Project	M6 Diesel site at Saredon & M54-M6 link road		
Document Number	SAR-BWB-GEN-XX-RP-TR-0003	BWB Ref	NTH2442
Author	Simon Hilditch	Status	S2
Checked	Alan Darby	Revision	P1
Approved	Peter Selfe (M6 Diesel)	Date	02.11.2020

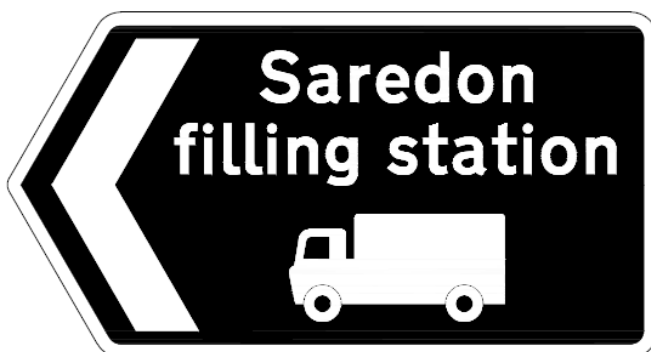
- 4.11 The exact signage positions and sign faces would be a matter for the Applicant to determine. However, our request is for standard geographical "HGV route" signage of the style indicated below, commencing on the M6 J11 and M54 J1 diverge slip roads. The signage legend uses standard geographical wording rather than the M6 Diesel branding.
